DWN C. LACHALL	DATE 4-27-90	PROD ASSUR C. May 01	DATE 9006-28	BOEING HELICOPTERS DRAWING CHANGE NOTICE DCN 77272		DWG NO. 145G0293
CHK W. AYMEN	4-30-90	WT		REASON UPDATE DWG AFTER SUCCESSFUL FIT & FUNCTION DEMONSTRATION & MAKE REVISIONS TO IMPROVE OPERATION		SH 1 OF 2
ENGR M. Juchak	6/27/90	MAT'L & PROC A.C. 7-16-90		CODE D.I.M.P. OF TOOL		REV A
STRUCT		CUST C. Curcio	6/27/90	ORIGIN GSE 7931		DWG SH
PROJ D. J. Juchak	6/27/90	CUST C. Curcio	16 JUL 90	CLASS PER MIL-STD-480 <input type="checkbox"/> CLASS I <input checked="" type="checkbox"/> CLASS II		MODEL/ITEM NO. 414-100 / PIN 26300
PL REPLACES	QTY REQ'D	CODE IDENT	PART OR IDENTIFYING NO.	NOMENCLATURE OR DESCRIPTION		CHANGE NO. WA6352X
SH/ZONE				MATERIAL AND SPECIFICATION		SPARES AFFECTED <input checked="" type="checkbox"/> YES <input type="checkbox"/> NO
						HT TR FINISH PT MK

-1 ALIGNMENT FIXTURE ASSY

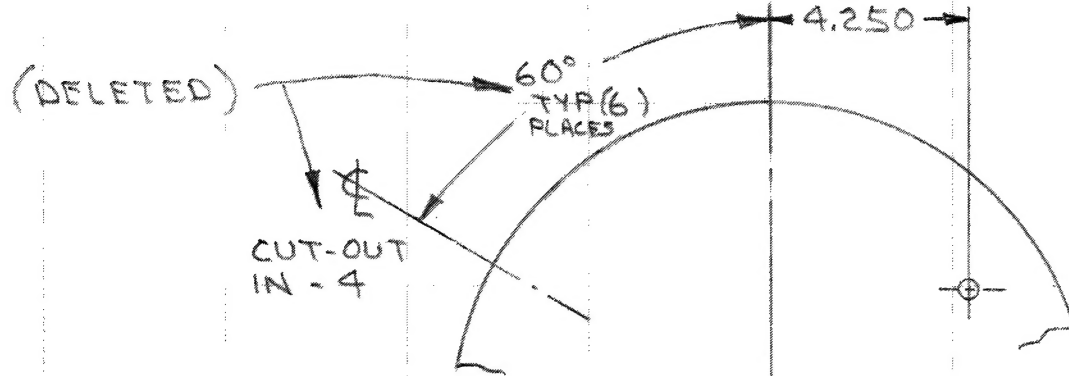
ZONE B-3, REVISED CALL-OUT AS SHOWN:

4 CUT-OUTS @ 90°
(FOR -3 ONLY)
(ADDED)

ZONE C-3, ADDED CALL-OUT AS SHOWN:

6 CUT-OUTS @ 60°
(FOR -4 ONLY)
